Modification of 804526 and 804570

Part Number: 804526 / 804570

For Vehicle: Nissan and Renault Applications

New design of 804526 / 804570

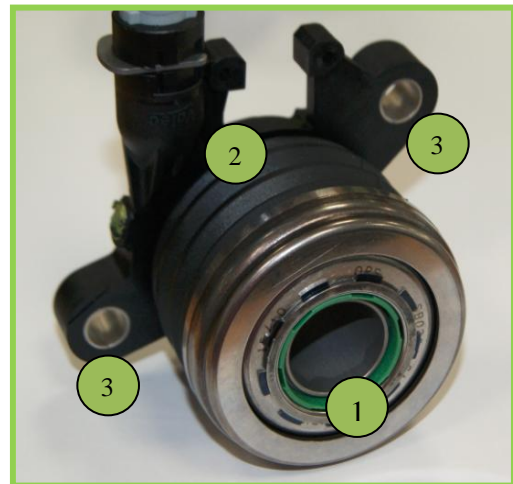
Please note there have been several design changes on concentric slave cylinders 804526 and 804570. The changes are as follows:

- Seal with metallic insert > full rubber seal 80Sh
- New plastic piston (1)
- Removal of rubber boot (2)
- Ribs on the bolt fixing body (3)
